REPLACEMENT SYSTEM VARIANCE REQUEST

M 14217

Town of Augusta

System's Location: 12 Spring Road RR7 Box 1815 (STREET)

DISPOSAL AREA CROSS SECTION

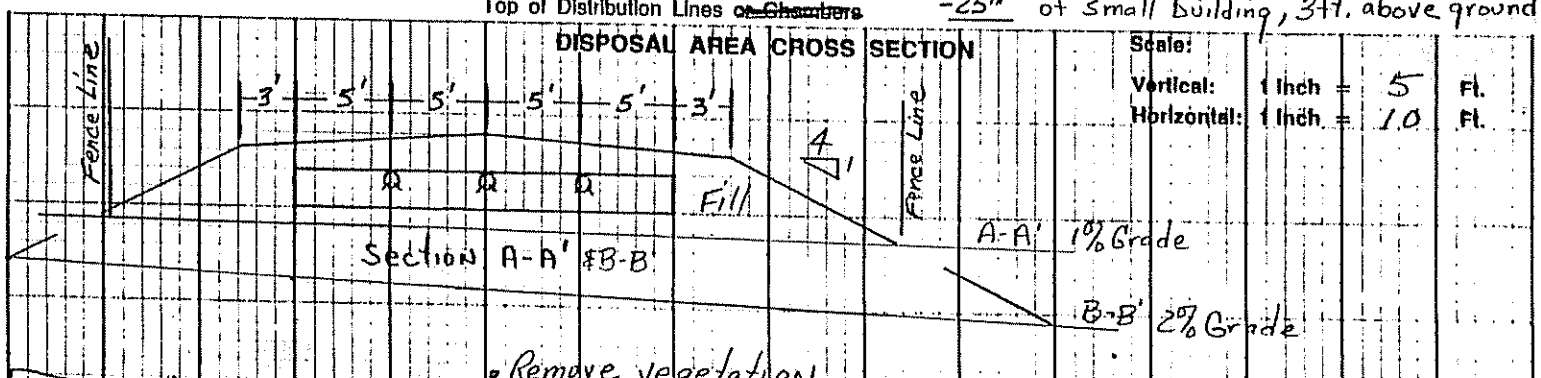
1. ~~Fill extension Grade — to 3:1~~ Reduce fill extension slope slightly to remain on property
2. Existing filled soil has been used for design purposes. Fill that appears to be at least
3. 20 to 25 years on site has replaced the original soil profile. which I believe approximate original site conditions.
